### COLLIN COUNTY, TEXAS

ADDENDUM No. Two (2)

### <u>CONSTRUCTION, NEW OFFICE BUILDING FOR PRECINCT 2</u> <u>JUSTICE OF THE PEACE & CONSTABLE</u>

Architect's Addendum Number Two

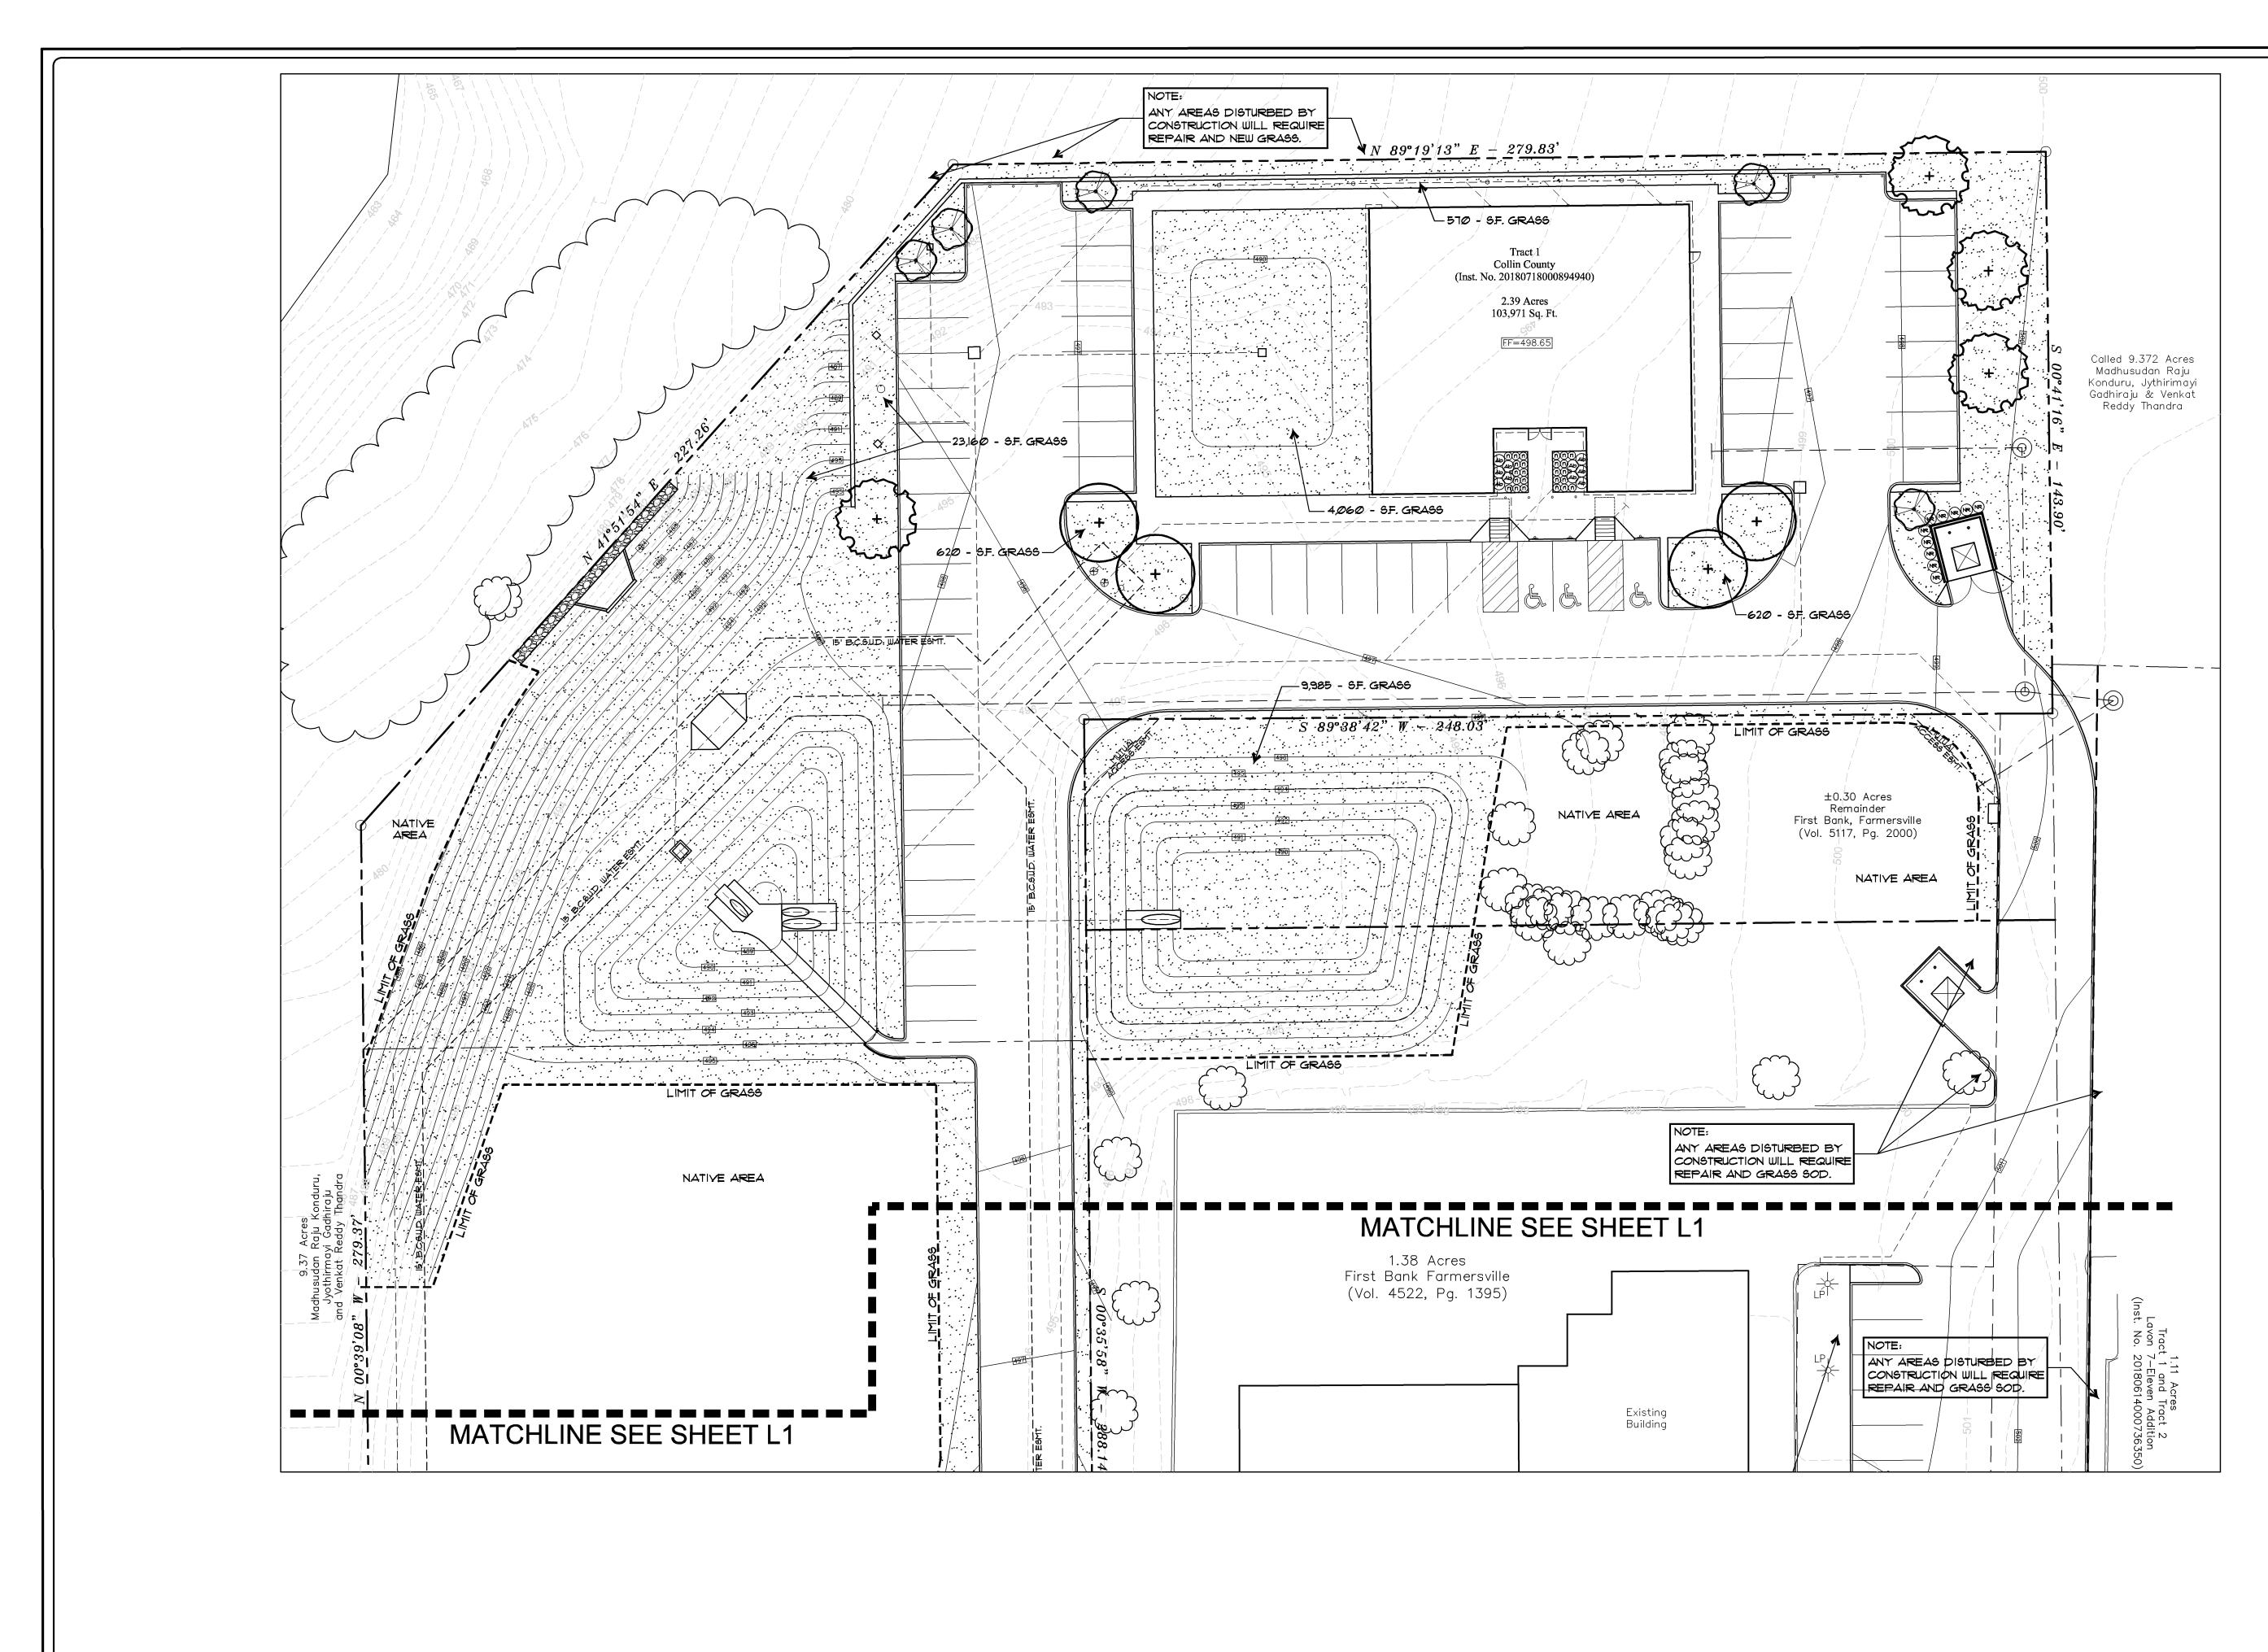
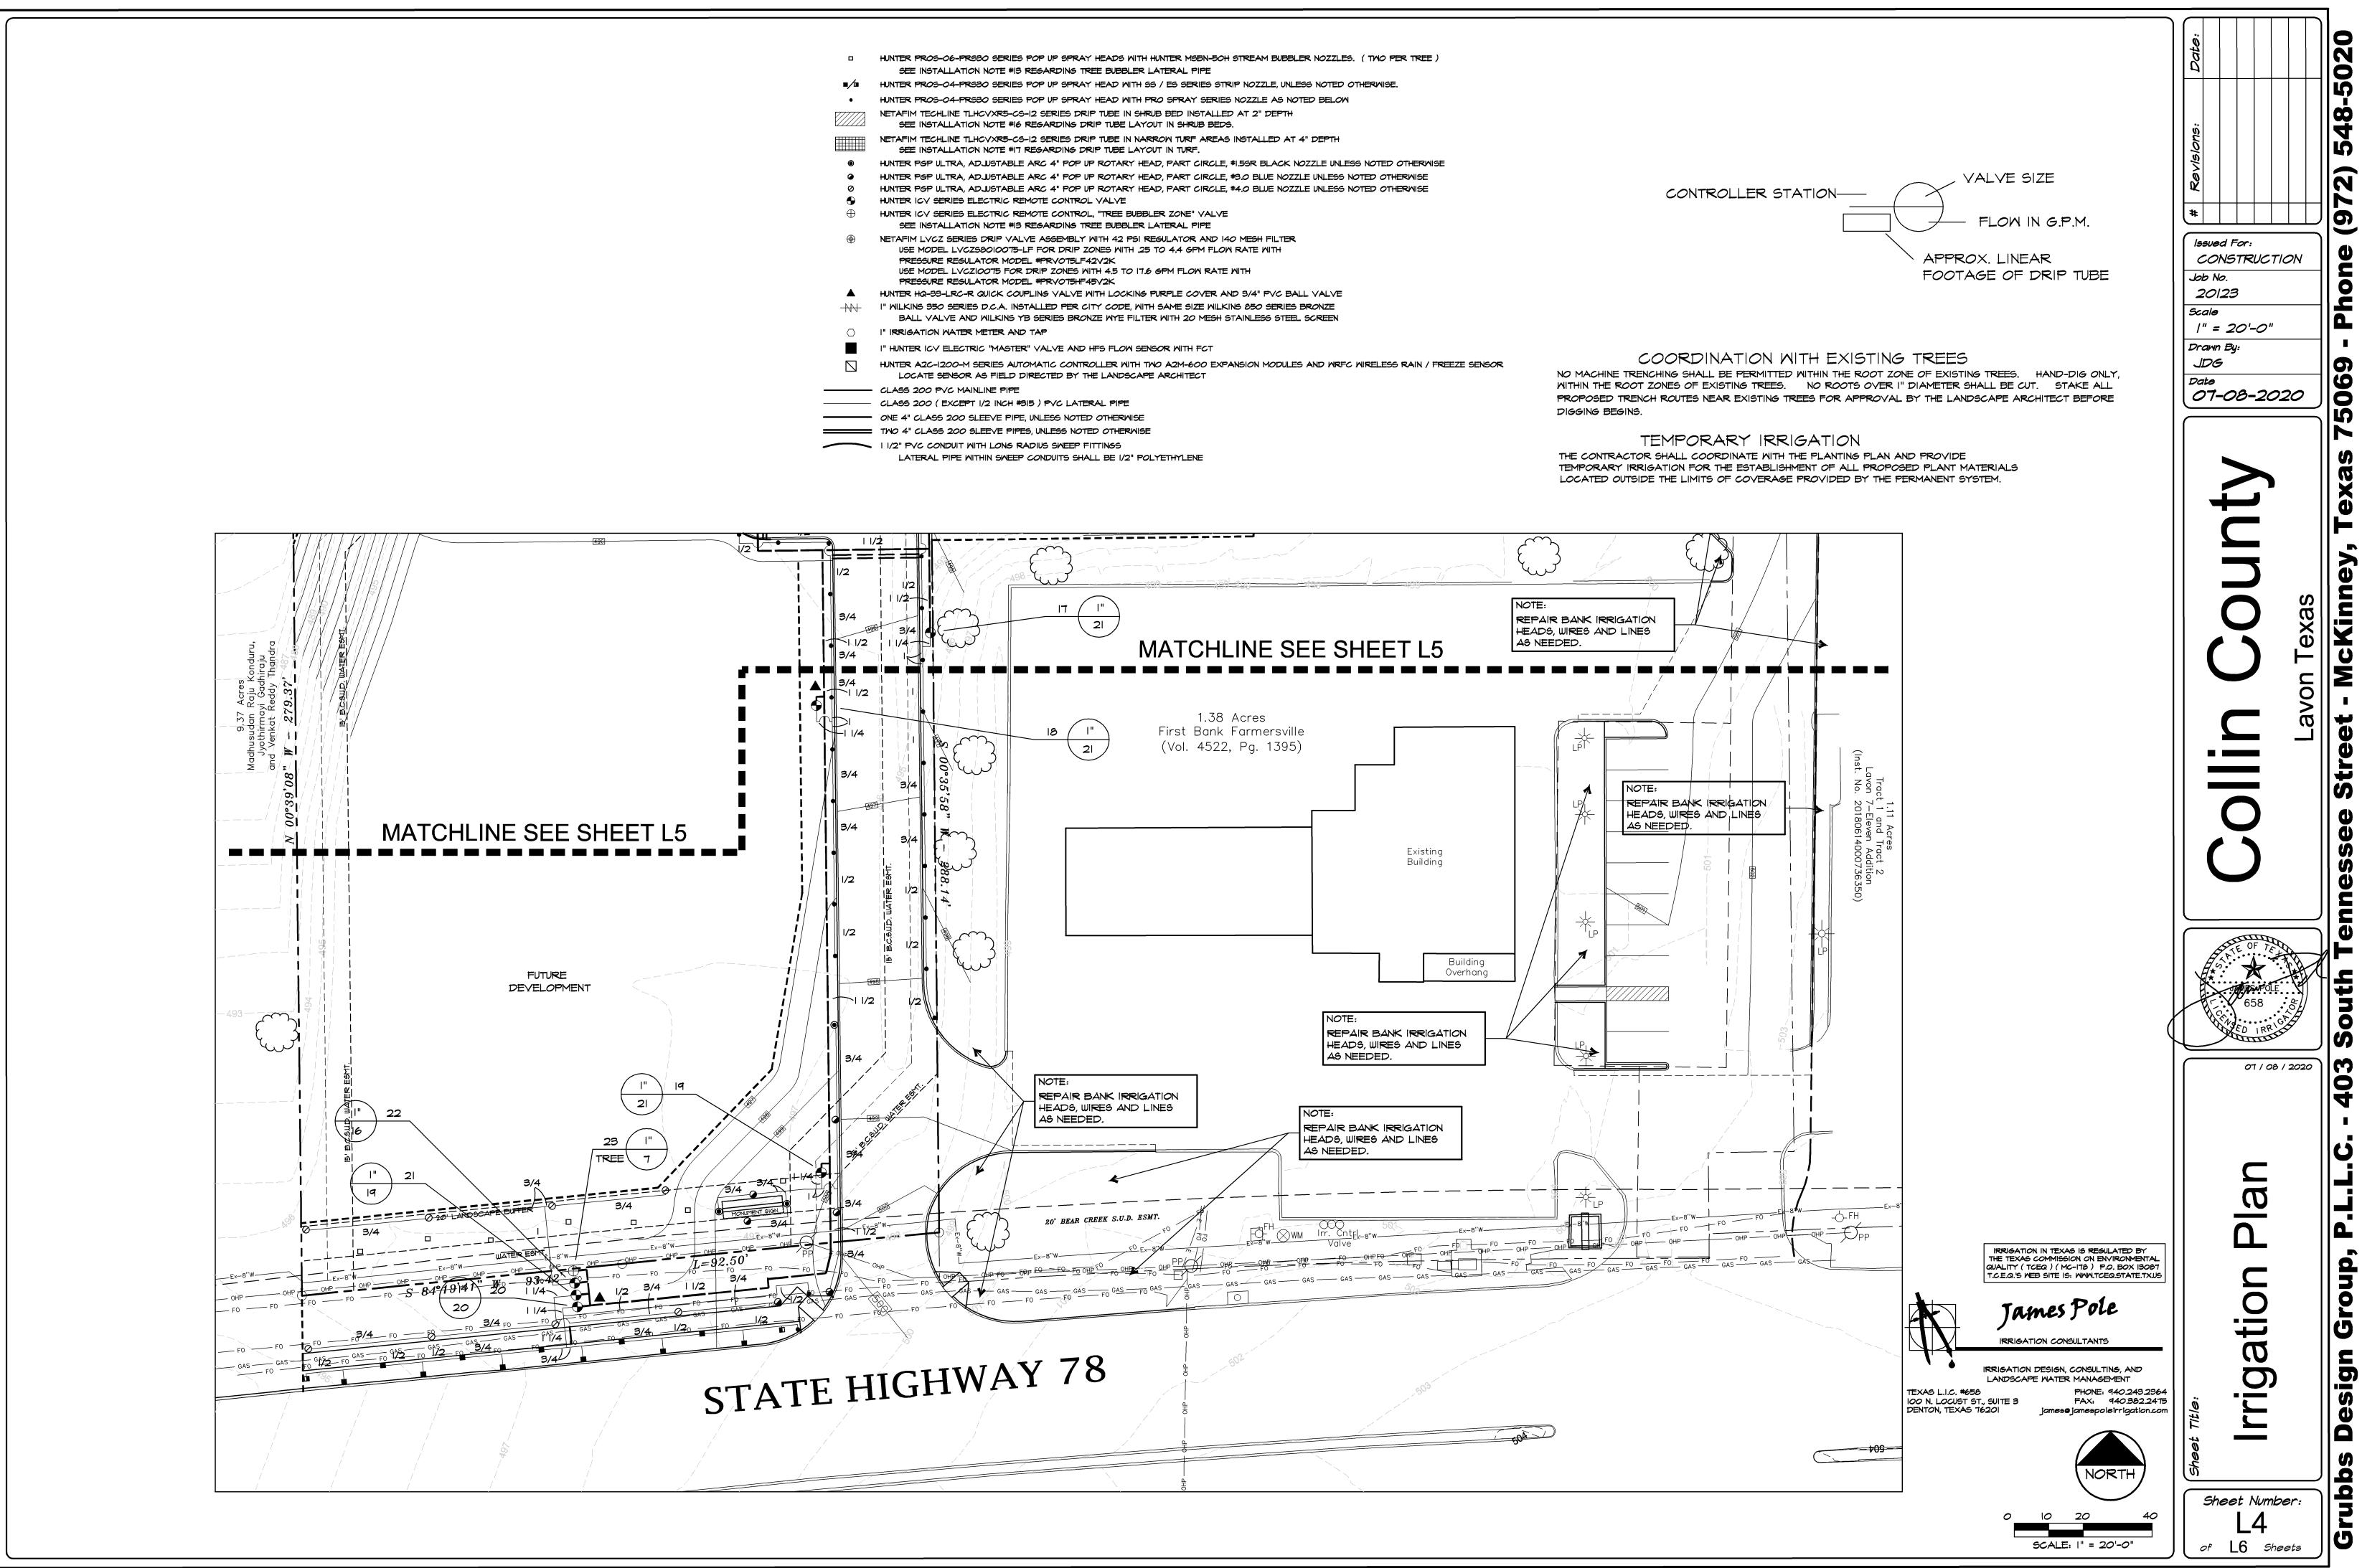
- Item 6: Corrections: Refer to attached Landscape & Irrigation Drawings L1, L2, L4 & L5: Additional notes have been added regarding sod and irrigation system repairs on the bank property, particular east of the bank where LS islands around the site light poles and parking are being modified and in the SW corner of the property where the bank's approach is being removed and the drive extended across the property line to the new approach.
